September 19, 2025

## **ADDENDUM NO. 1**

### **DNR-250004 GREAT COUNCIL OBSERVATION TOWER**

1587 US-68,  
Xenia, OH 45385

3 Reflected Ceiling Plan Demolition  
1/4" = 1'-0"

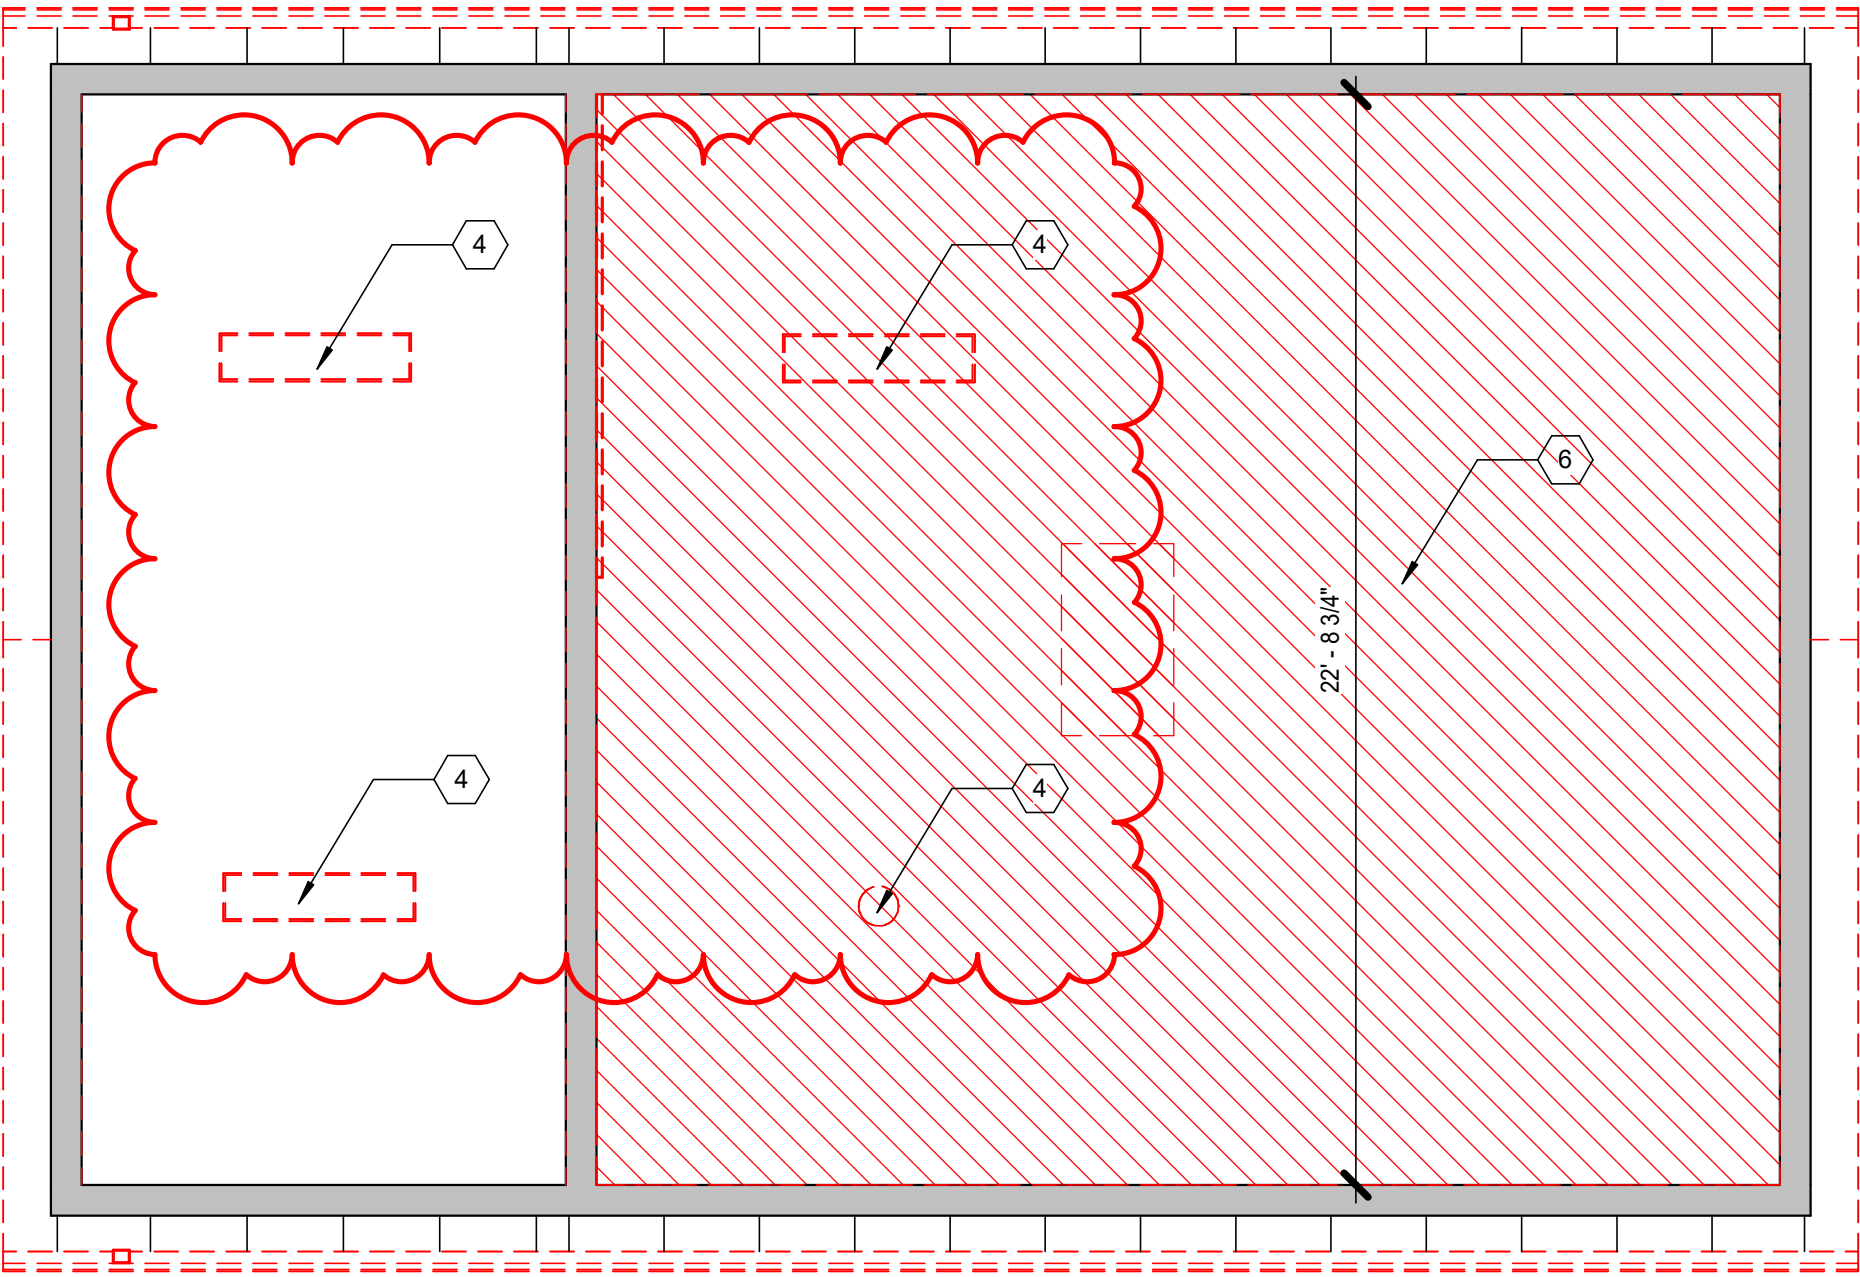
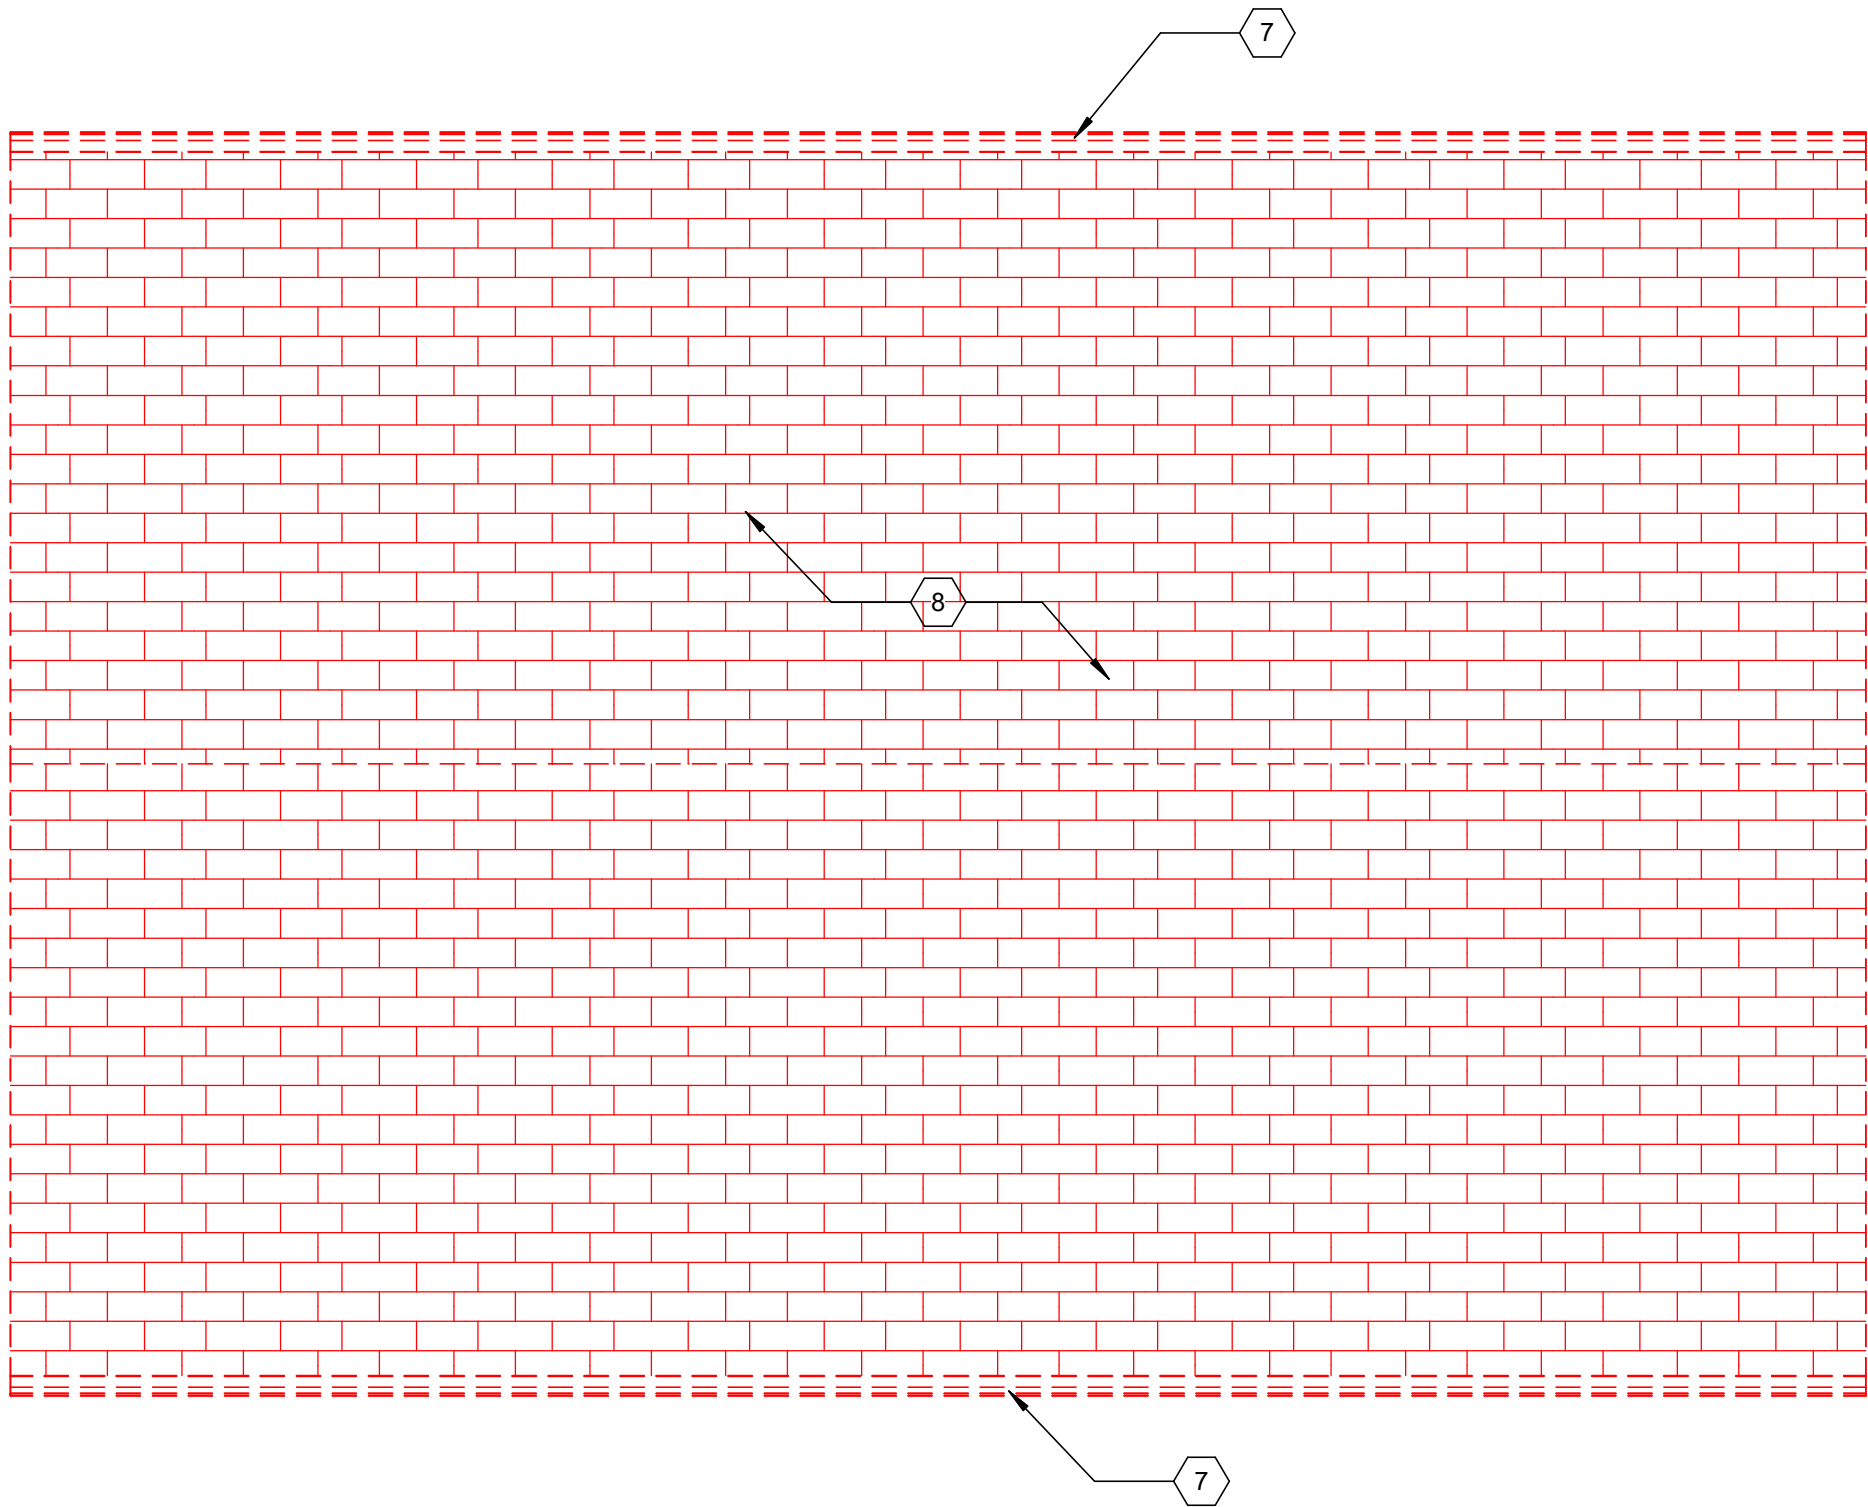
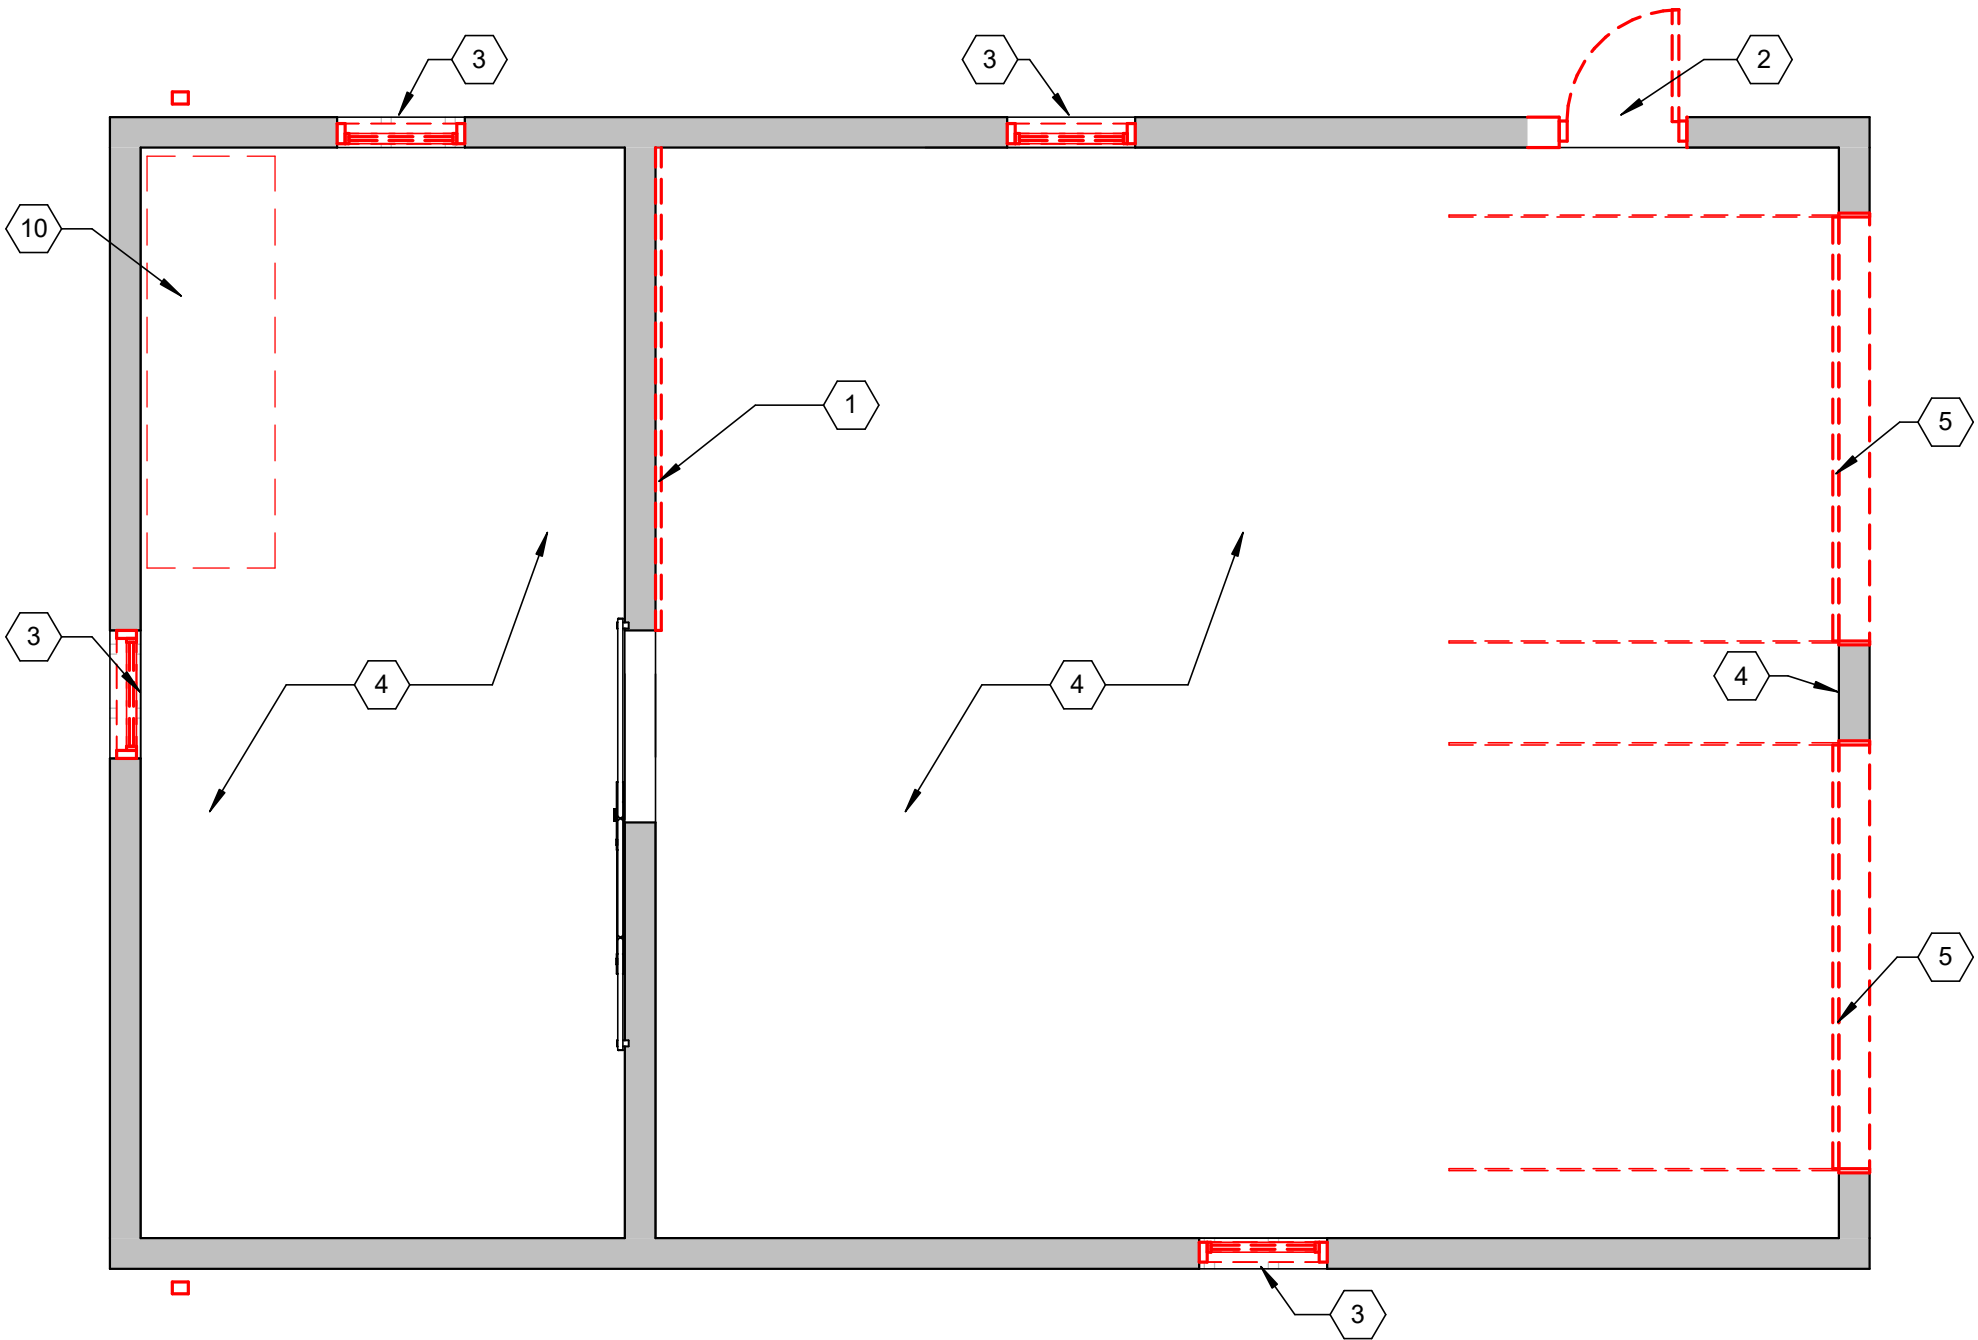
### **ITEM 6 M-AD1 – FLOOR PLAN DEMOTLITION**

Added light fixtures for demolition to reflected ceiling plan.
